## Design Upgrade BM880

PRMPA2202

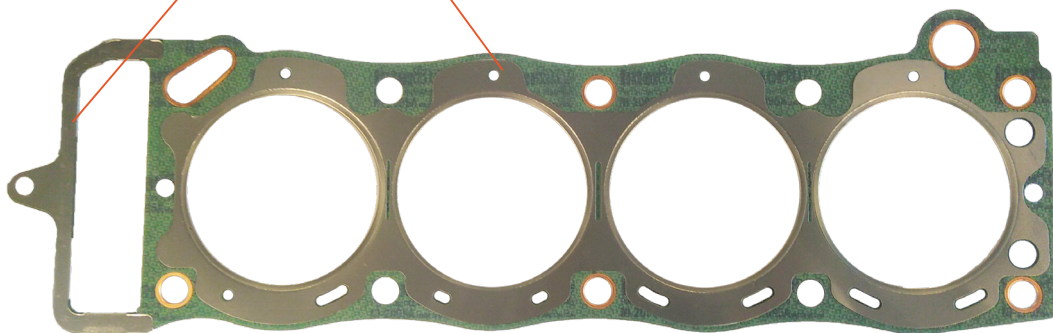
Due to technical advances in cylinder head gasket technology it is sometimes necessary to change the materials used in our products. We have consequently **upgraded the facing material** used for BM880 **from graphite foil to a modern fibre based material**. This will provide greater resistance to the effect of hot oil as well as improved crush resistance under the bore eyelets.

We have also taken the opportunity to **locate the bore shim on the head side of the gasket**. Whilst this will not make any difference to the load balance on the gasket, it will offer a greater resistance to thermal movement of the cylinder head and enhance the gasket durability.
